Technical Bulletin
Tech 064
Full Distribution

Service Information for Ford Transit 2.2L
Front Wheel Drive - Turbochargers 786880

Identification of REA/SREA and UTA/sUTA actuators

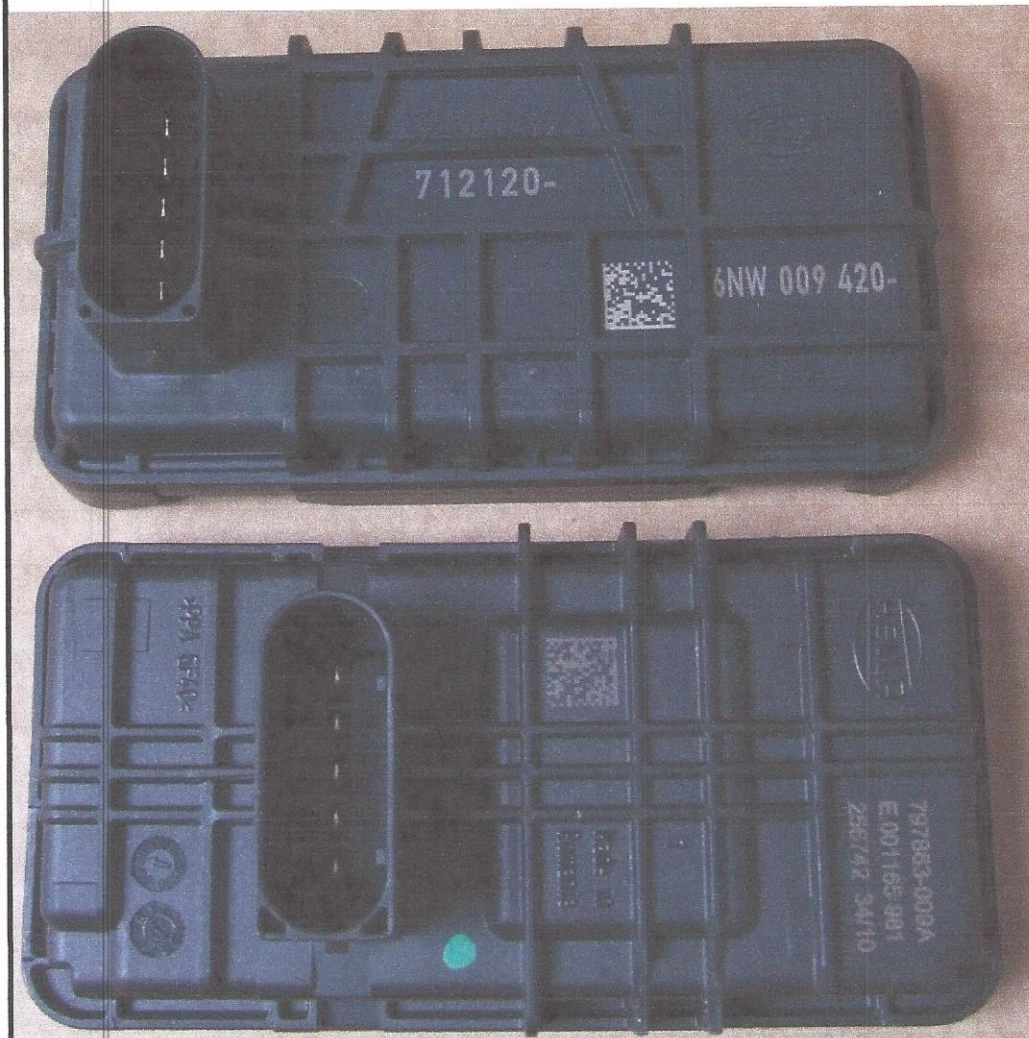
786880-5021S is a Direct Service Replacement for -5006S
Both of these turbos use an SREA (Simple Rotary Electronic Actuator).

786880-5012S is equipped with a newer type of actuator, the sUTA (Simple Universal Turbo Actuator).

This is not interchangeable with -5006S and -5021S.

On this Ford Transit application, it is not possible to interchange between the SREA and sUTA equipped turbos due to changes in the wiring harness on the vehicle.

See page 2 which shows the different connectors.

Top: REA and SREA connector block location

Bottom: UTA and sUTA connector block location
